# CITY OF PORTLAND BUILDING PERMIT

Job ID: 2011-07-1652-ALTR

has permission to Amend Permit #2011-07-1652 with Structural Framing Modifications, ½ bath not approved provided that the person or persons, firm or corporation accepting this permit shall comply with all of the provisions of the Statues of Maine and of the Ordinances of the City of Portland regulating the construction, maintenance and use of the buildings and structures, and of the application on file in the department.

RE: 93 Westland Avenue Renovation project

SK-1  
1 OF 5

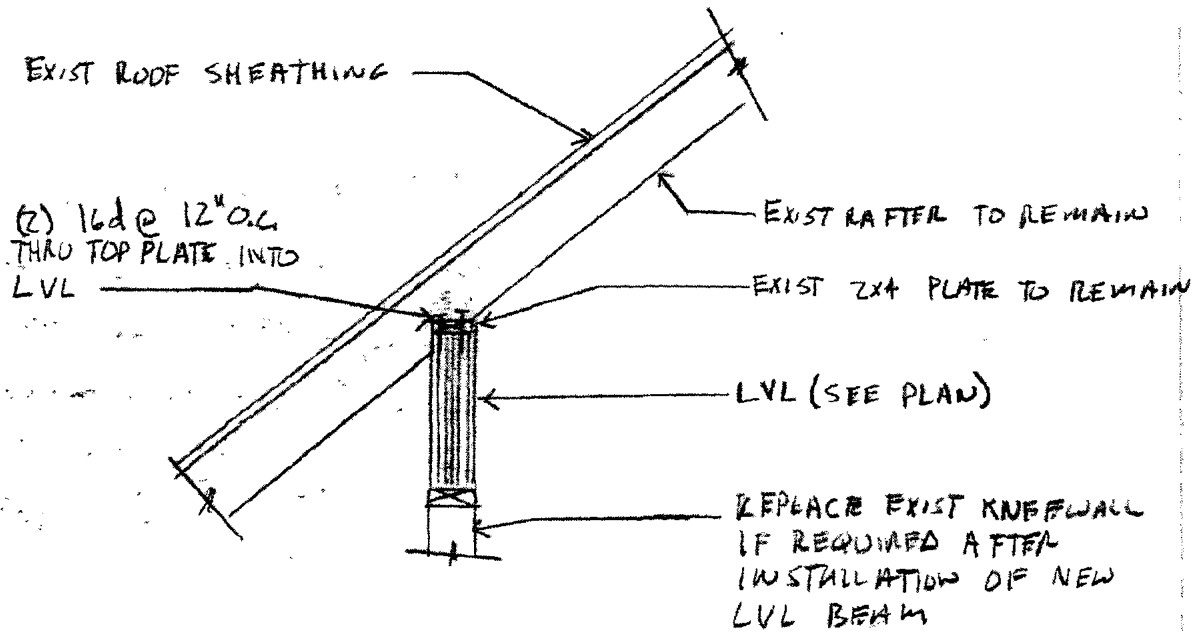
The first item I reviewed was a ridge beam running from the southwest side of the house (labeled Ridge Beam 3 on Sketch SK-1). The ridge beam is a 1 3/4" x 11 7/8" LVL, and spans approximately 23'-0". This existing ridge beam was found to be overstressed according to current building code requirements. It is recommended that the contractor install a vertical support to reduce the span of the ridge beam to meet current building code requirements. The installation of this support is detailed on the attached sketches.

SK-6

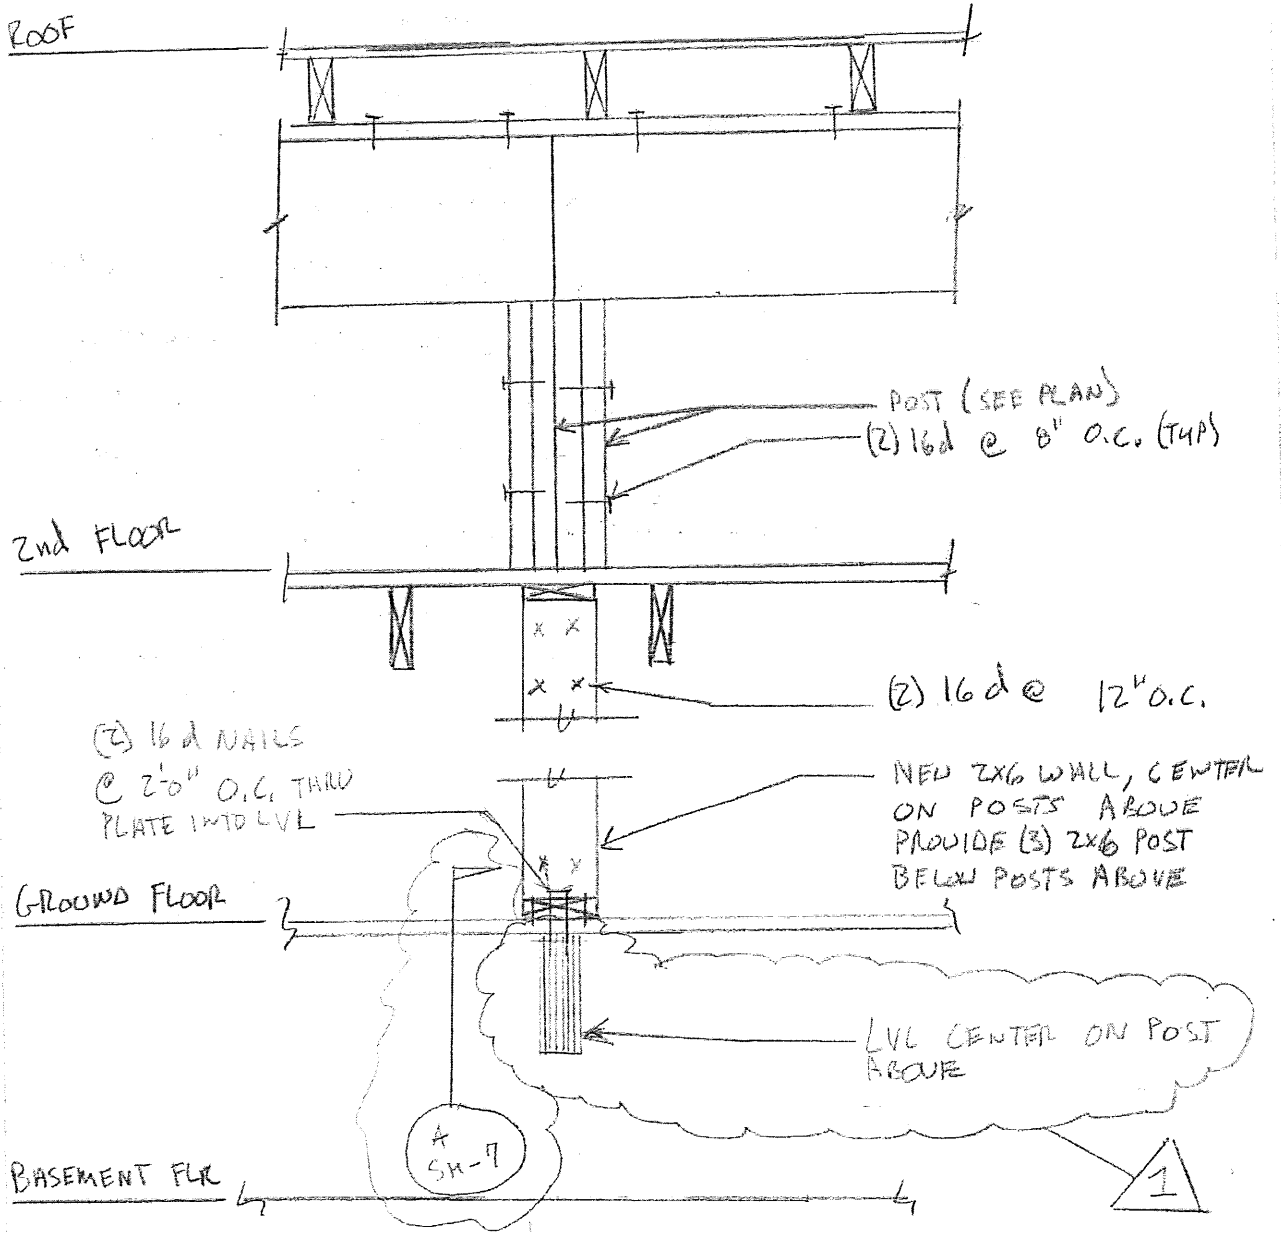
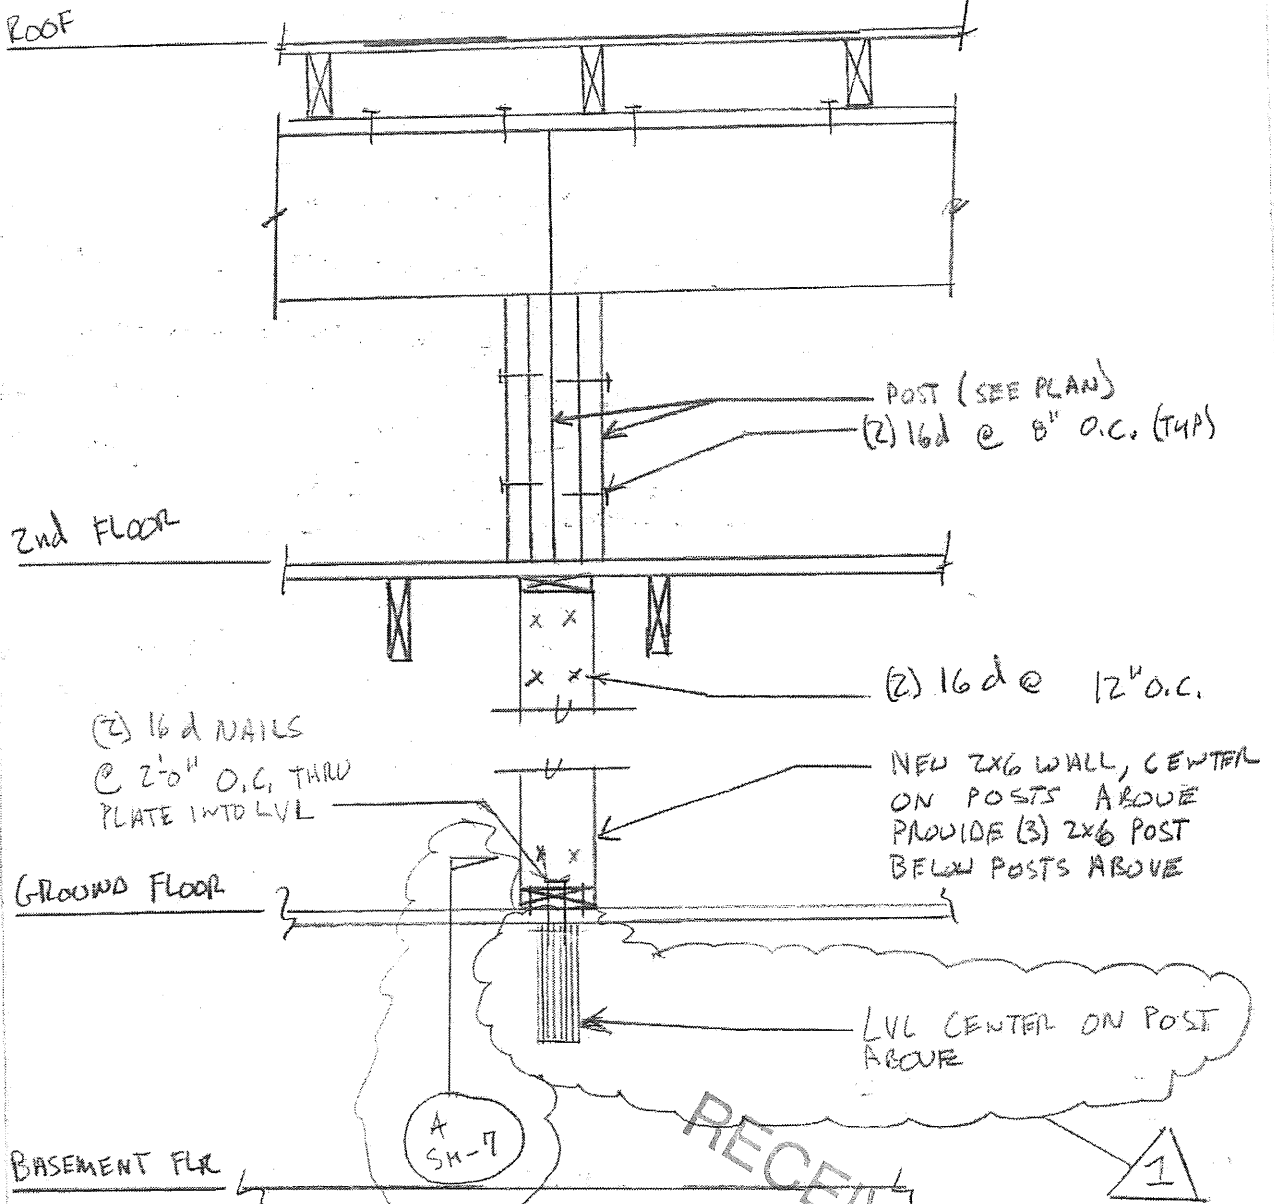
Please find an engineer's drawing describing the posting of the LVL in the upstairs that was added to support the building's original roof at the kneewall. This modified drawing now includes an additional LVL and Simpson hanger in the basement that we decided to add so that the lolly column posting could be moved to the center-line of the building.

Plot Plan  
 93 Westland Ave  
 Chad Thompson

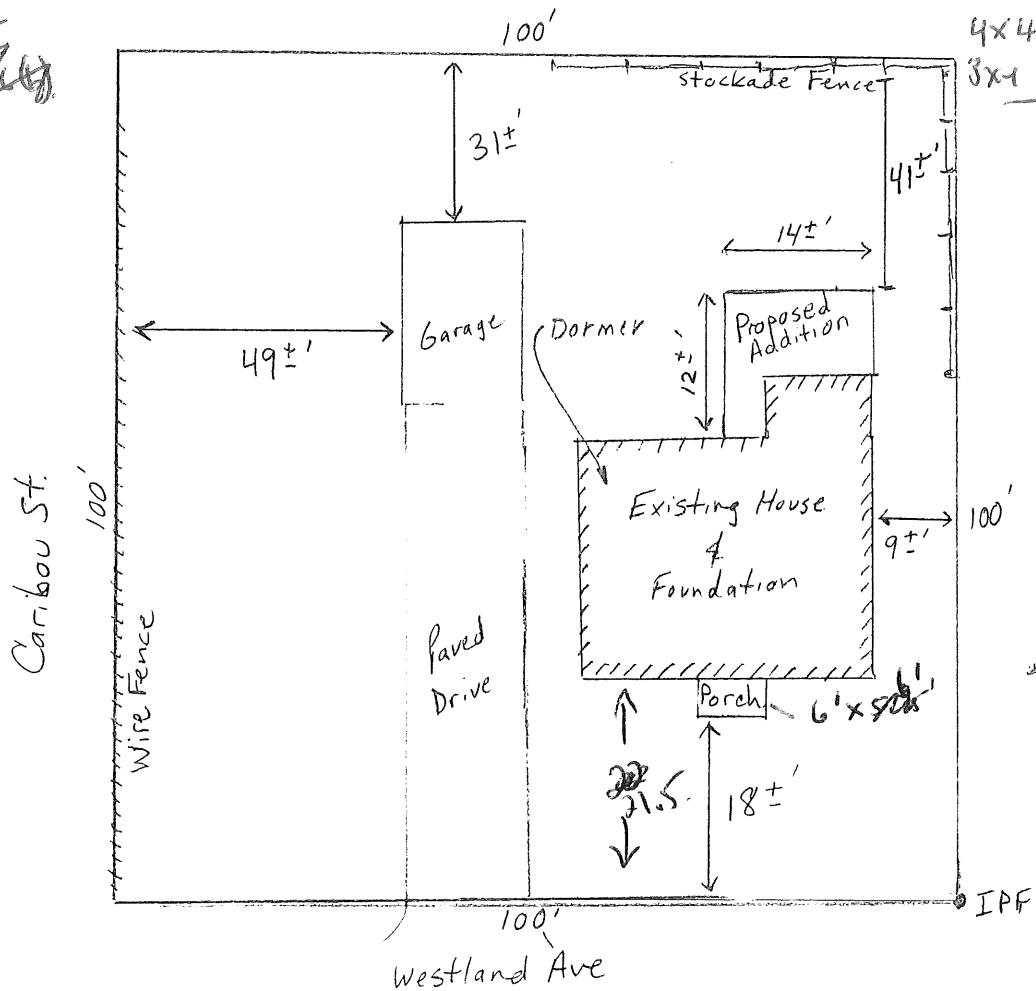
lot size - 10,000 sq ft  
 front 20' or average - ~~42' given~~ 21.5' house measure to that.  
 rear 20' - 41' given to addition (OK)  
 side - 2 sides - 12' - but can ~~be~~ reduce to 8' borrow  
 12' given but borrowing from other side (OK)  
 lot coverage - ~~4900~~ 4000

house 616  
 single 240  
~~14~~ 14x12 = 168  
 4x4 16  
 3x4 = 12  
 1052 sq ft OK

Proposed 12' x 14' Addition

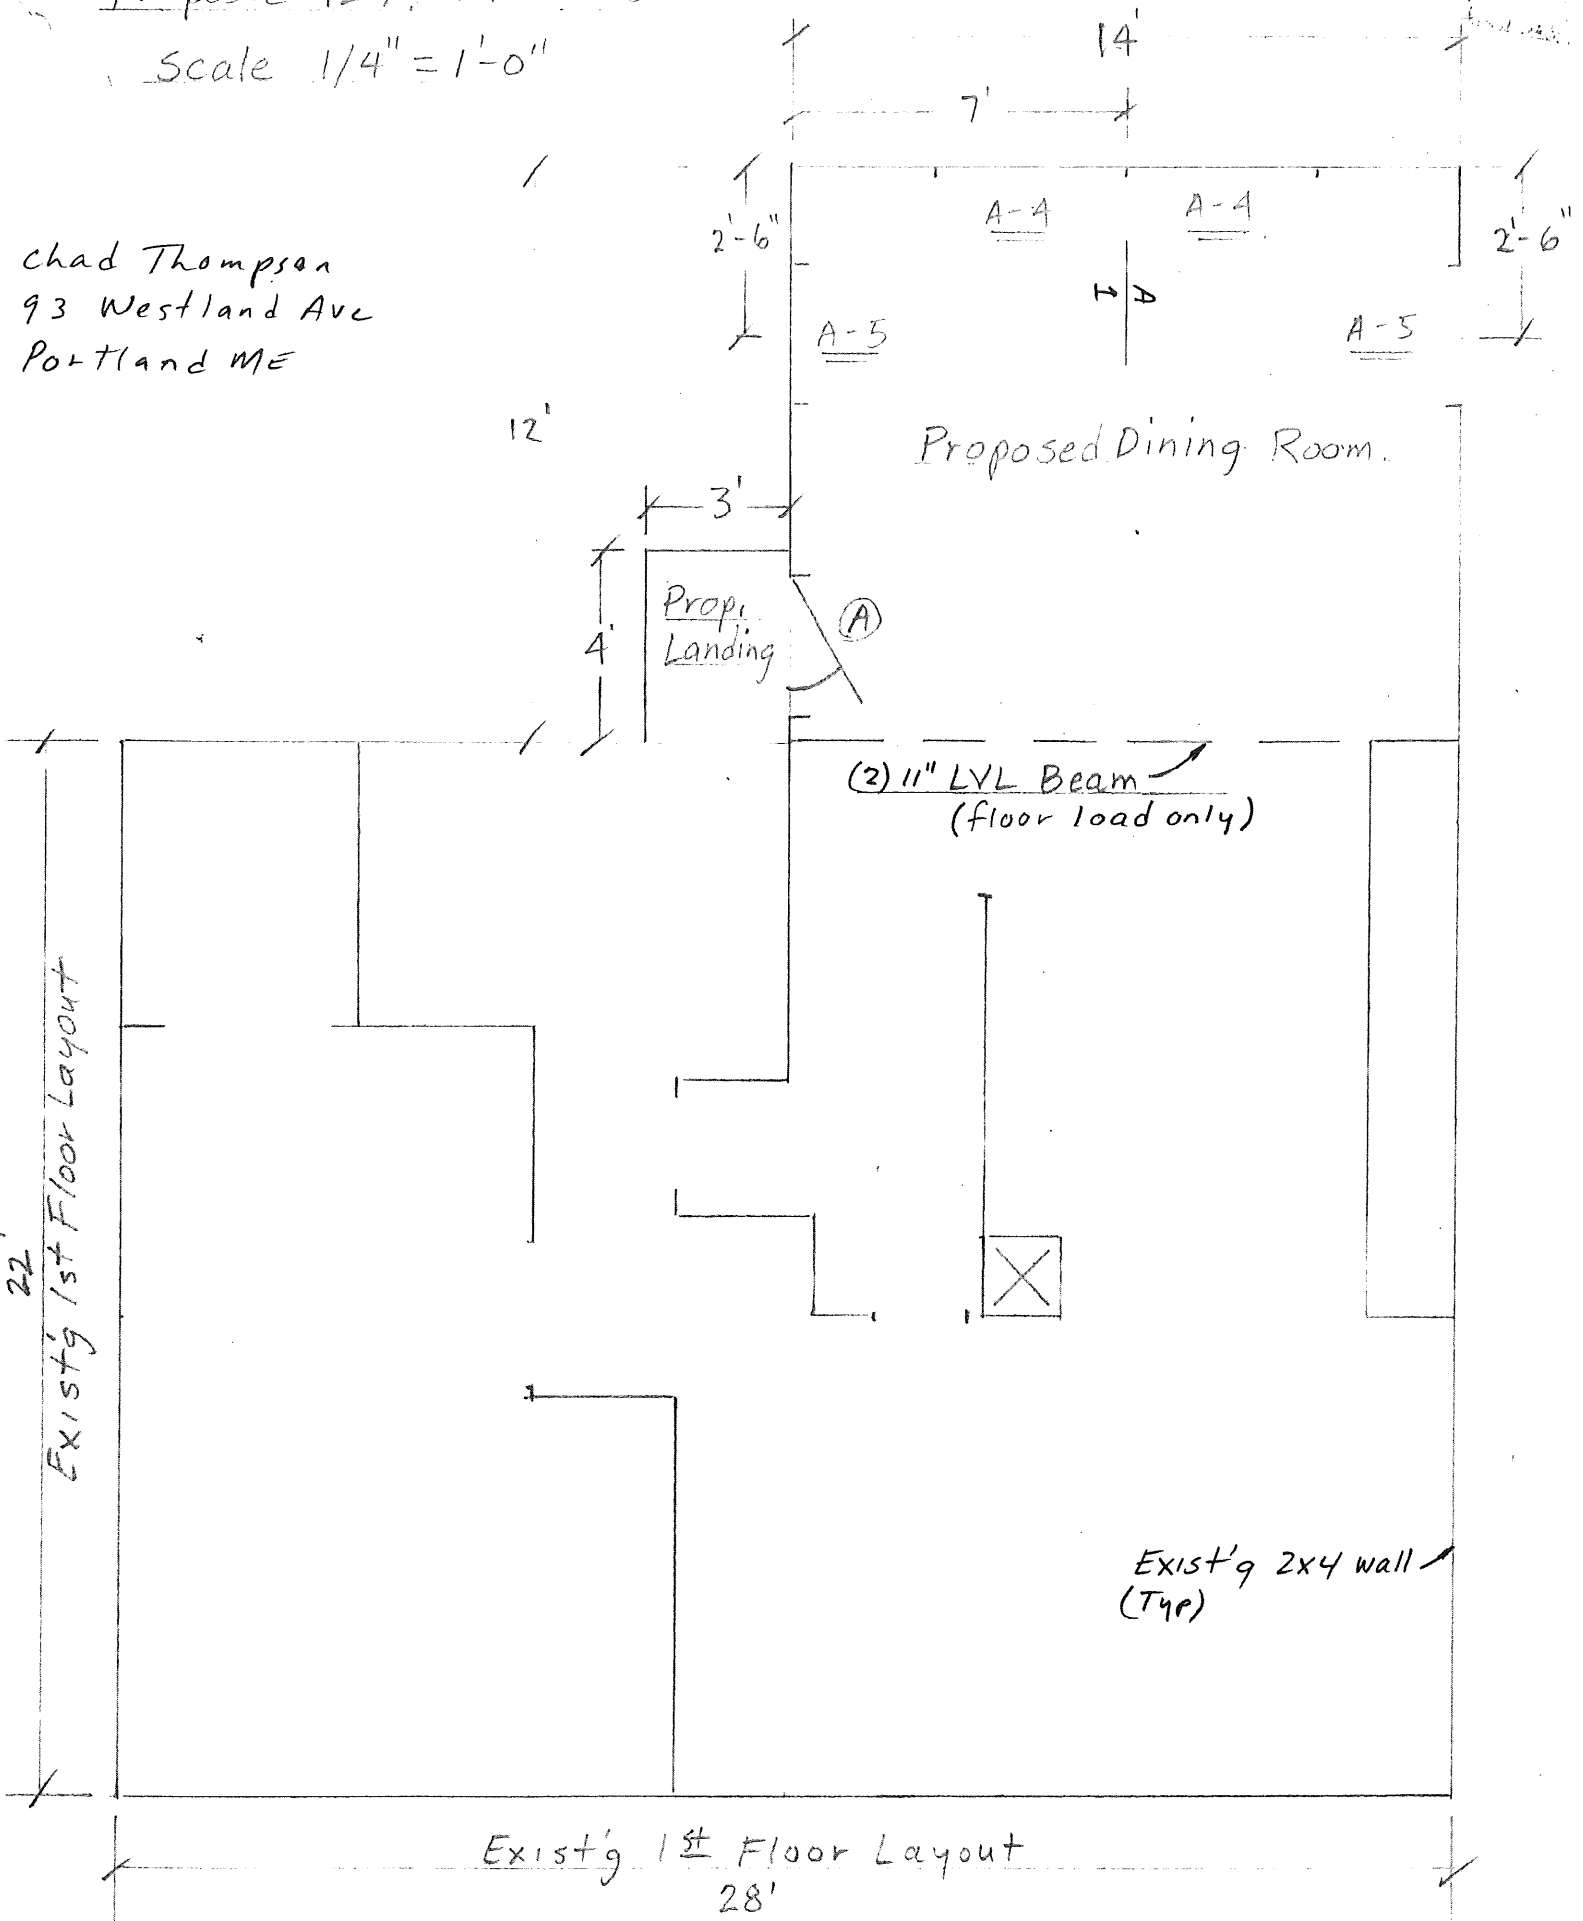
Is any part of the renovation(s) [roof pitch] affecting the existing stairwell minimal headroom requirements, and is the proposed crawl space connected to an existing foundation? JGR.

3. The roof structure will use structural ridges for all locations. Please see attached engineer drawing for 12' span for the addition. All pitches are a 5 pitch. This will allow me to use (2) 2x10 valley rafters which will be hung from the LVL ridge shown on submitted plan #2, for plan view see submitted plan #5, they are supported by being posted to basement along the masonry chimney. I can amend drawing # 5 to show the valley rafters if you like. The addition ridge will tie into this point as well.
